Access Compliance Report

Public Rights-of-Way

(Curb Ramps)

Intersection ID: 20516	Main Street: OLD_PINEVILLE_RD	Cross Street: SILVERLEAF_RD	Location: SW
ADA ID: 2DA3A6BD964A	Ramp Type: Directional1	Initial Pass/Fail: Fail	Overall Compliance: No
		Severity Score: 1.25

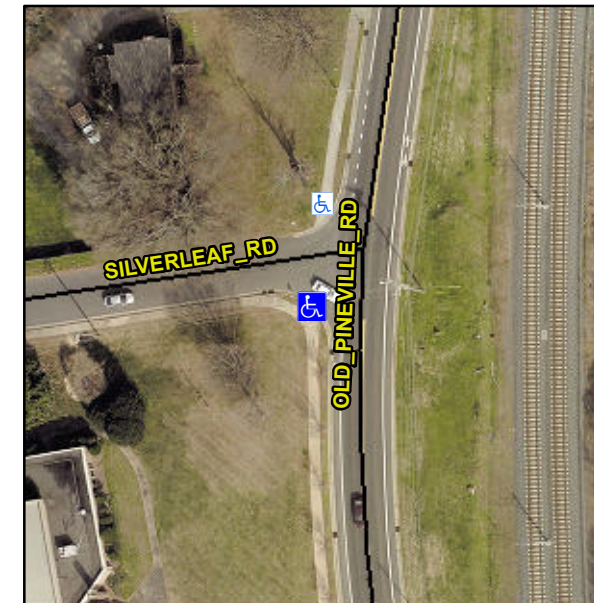
R304.5.3

Compliance	Description	Data	Compliance	Description	Data
N/A	Ramp Length (in)	121.0	N/A	Grade Break?	N/A
Yes	Ramp Width (in)	78.0	N/A	Grade Break Slope (%)	0.0
Yes	Ramp Slope (%)	2.7	N/A	Grade Break XSlope (%)	0.0
No	Ramp XSlope (%)	3.4			
N/A	Flare Type LT	N/A	N/A	Flare Type RT	N/A
N/A	Flare Slope LT (%)	N/A	N/A	Flare Slope RT (%)	0.0
N/A	Flare Traversable LT?	N/A	N/A	Flare Traversable RT?	N/A
N/A	Landing Length (in)	0.0	N/A	DWS Provided?	N/A
N/A	Landing Width (in)	0.0	N/A	DWS Contrast?	N/A
N/A	Landing Slope (%)	0.0	N/A	DWS Length (in)	N/A
N/A	Landing X Slope (%)	0.0	N/A	DWS Full Width?	N/A
N/A	Landing Curb? (Y/N)	N/A	N/A	DWS Offset LT (in)	N/A
N/A	Shared Landing?	N/A	N/A	DWS Offset RT (in)	N/A
N/A	Gutter Ponding?	0.0	N/A	Gutter Slope (%)	N/A
N/A	Gutter Lip Ht (in)	0.0	N/A	Gutter X Slope (%)	N/A
N/A	Painted X Walk1?	No		Road Slope (%)	0.9
	X Walk 1 Direction	To N		Road X Slope (%)	1.4
	X Walk 1 Width (in)	N/A		Clear Space?	N/A

Remove & Replace Entire Ramp.
